Installation of New ALPS Treated Water Dilution/Discharge Facilities and the Related Facility

Tokyo Electric Power Company Holdings, Inc.

Responses to major issues^(*) concerning the content of the application for the Discharge Facility of ALPS Treated Water into the Sea

*Document 1-2 for (The 3rd) Review Meeting on the Implementation Plan Regarding the Handling of ALPS Treated Water

Table: Results of internal exposure assessment when each nuclide is discharged at the regulatory concentration limit (Adult)

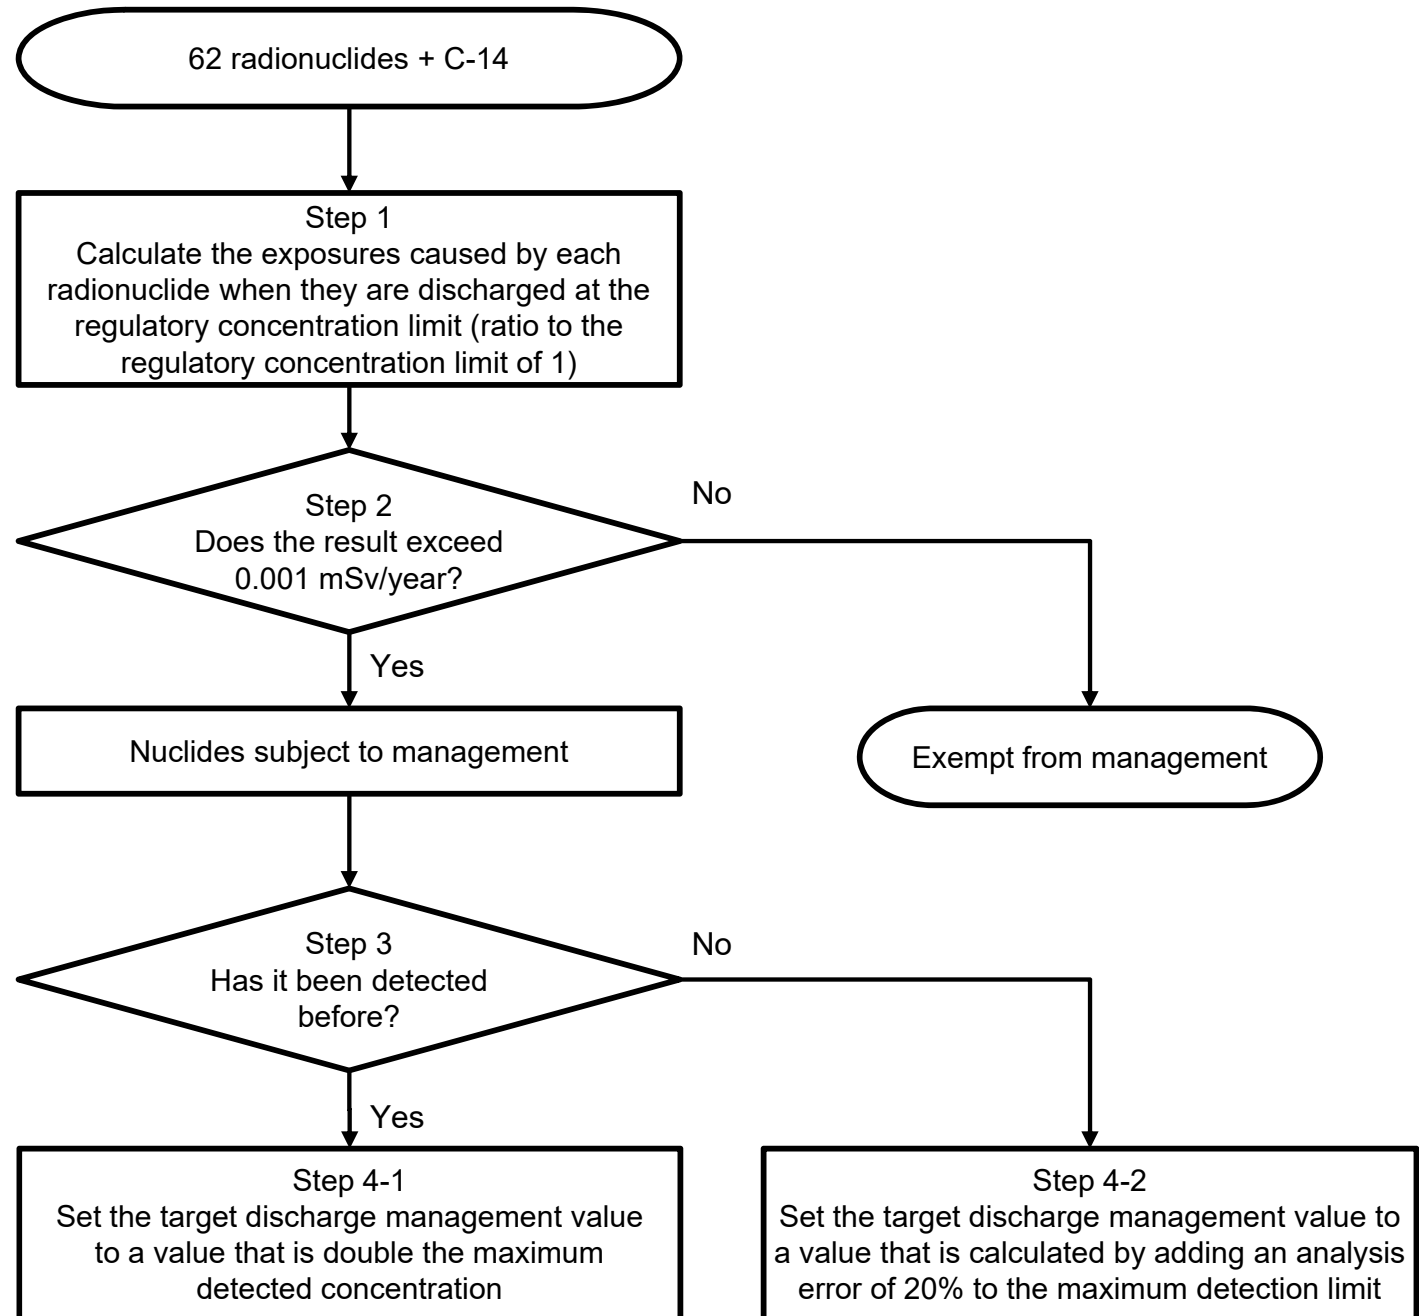
- Regarding **source terms that have been set based on the upper limits for discharge management**, the rationale and validity of the setting must be explained, including the procedures for selecting radionuclides subject to management. In addition, an explanation must be given regarding how the annual discharge of tritium was evaluated while taking into account annual changes in the operating rate of the facilities for the discharge into the sea.

- The discharge of ALPS Treated Water is managed based on the sum of the ratios to regulatory concentration limits. However, even when discharged at the same concentration ratio, each radionuclide behaves differently in the environment. Therefore, radionuclides that have relatively large impact on exposure doses (= exceeds 0.001 mSv/year) when discharged at the same concentration ratio as the regulatory concentration limits were selected, and target discharge management values (upper limits for discharge management) were set for them to reduce exposures.

- As a result, setting a hypothetical ALPS Treated Water enable us to conduct a radiation impact assessment with the most conservative source term. The assumed Hypothetical ALPS Treated Water was : the water contains top 8 radionuclides, which have larger impact on exposure doses when discharged at the same ratio to the regulatory concentration limits, and followed zinc 65, which has the next largest impact on exposure doses, to make up the remaining portion of the sum of the ratios of 8 radionuclides mentioned above until the sum becomes 1.

- For nuclides that have been detected before: double the maximum detected value
- For nuclides that have not been detected before: 1.2 times the detection limit
- The sum of the ratios of these 8 radionuclides is 0.32

-> ALPS Treated Water that contains nuclides at concentrations that exceed the target discharge management values will be repurified until the concentrations satisfy the discharge limits, even if the sum of the ratios of the 63 radionuclides is less than 1.

Fig. 1: Comparison of the calculated Cs-137 concentrations near Iwasawa, Fukushima Daiichi, with monitoring results (MA) is the 14 day moving average.

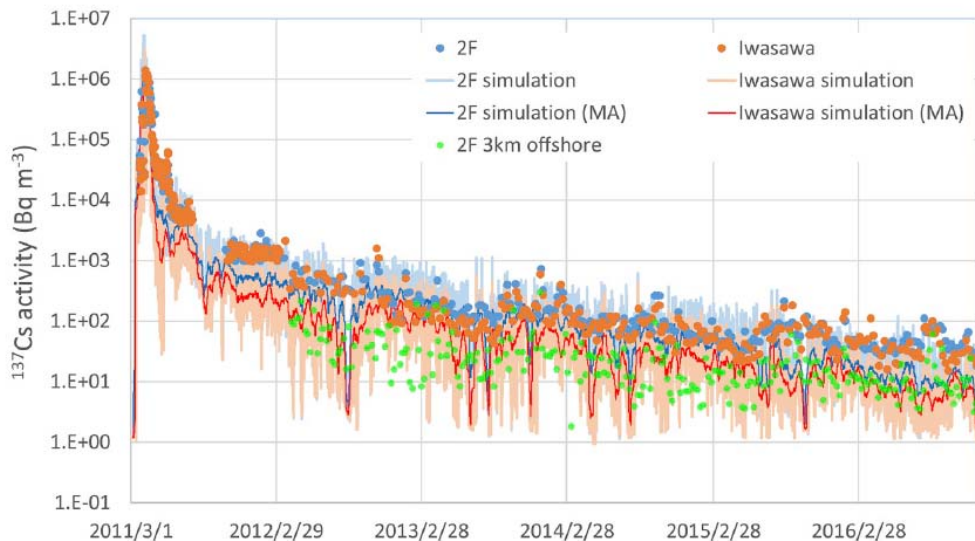
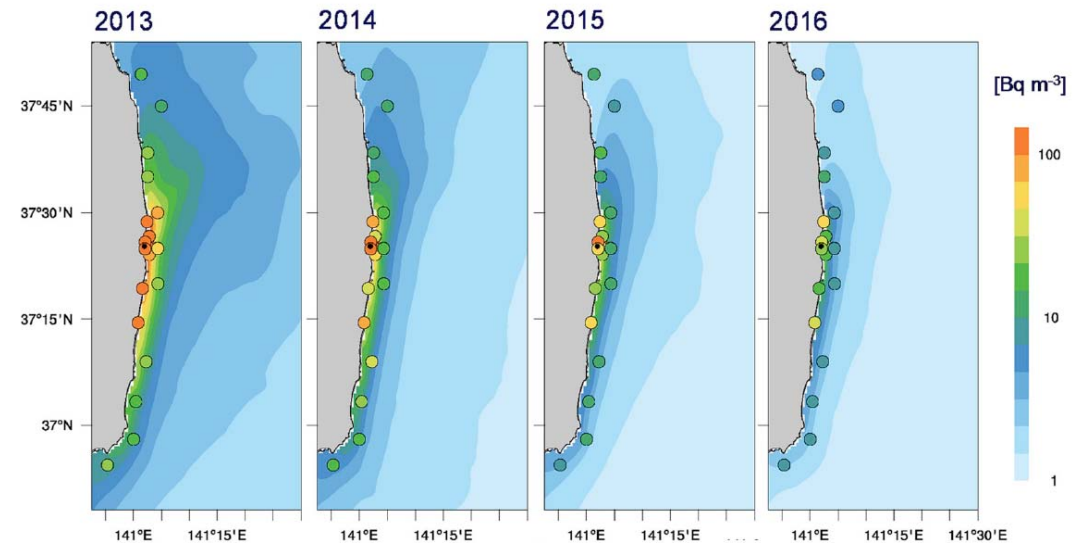
- The validity of **the dispersion model** for this radiation effects assessment must be explained by showing how this model simulates the dispersion in the sea around the Fukushima Daiichi NPS. Furthermore, the adequacy of the scope of modeling must also be explained, for example, by showing concentrations of radioactive materials at the boundaries of the modeling scope.

- The model used for the dispersion calculation in the sea area has high reproducibility. To verify the model, calculations to reproduce the concentration in seawater of cesium leaked as a result of the accident at Fukushima Daiichi NPS were performed using the model based on actual past weather and sea conditions data, and the results were compared with actual measured data*.
- ✓ Fig. 1 shows the results of the simulation of changes in concentration are generally consistent with the results obtained by the monitoring.
- ✓ Fig. 2 shows the simulation results of the annual average concentration are generally in agreement with the measured results.
- ✓ In both figures, in the concentration range below 10 Bq/m³ (0.01 Bq/L), the observed values tend to exceed the simulation results, which is estimated to be the effect of inflow from outside that is not covered by the simulation.

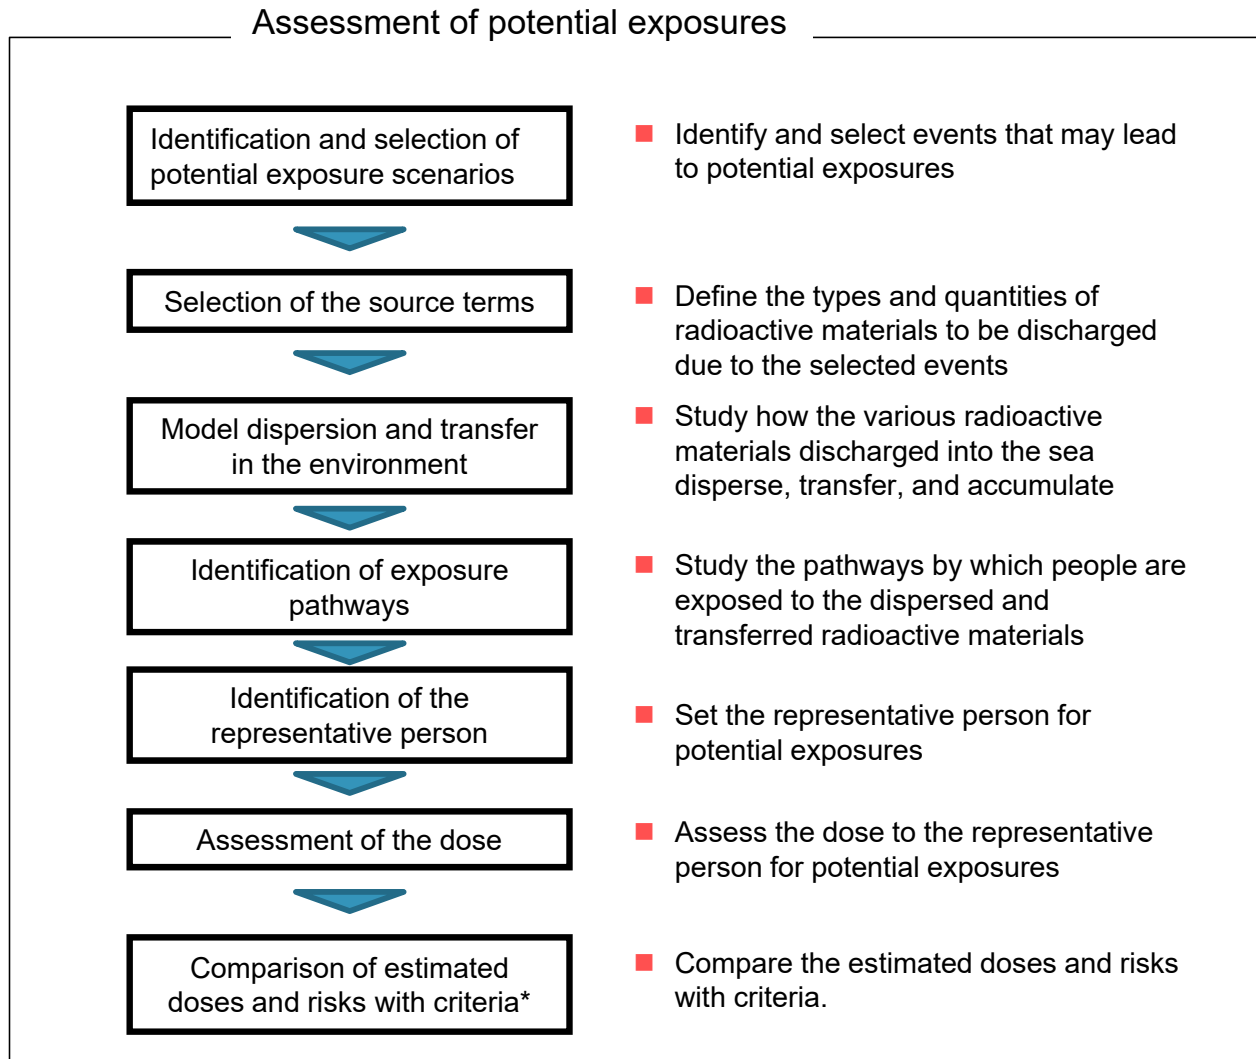
- Explanations must be given regarding why the impacts of potential exposures were assessed without using the flow chart in Figure 3 of GSG-10. The rationale for the setting of the scenario used for **the potential exposure assessment** must also be explained.

- The potential exposure assessment in the report is evaluated taking the similar method of the flow chart illustrated in IAEA GSG-10, although the citation of it omits.
- Facilities that are taken into account when considering potential exposure scenarios are those down-stream from the Measurement/Confirmation facility shown in the figure below.
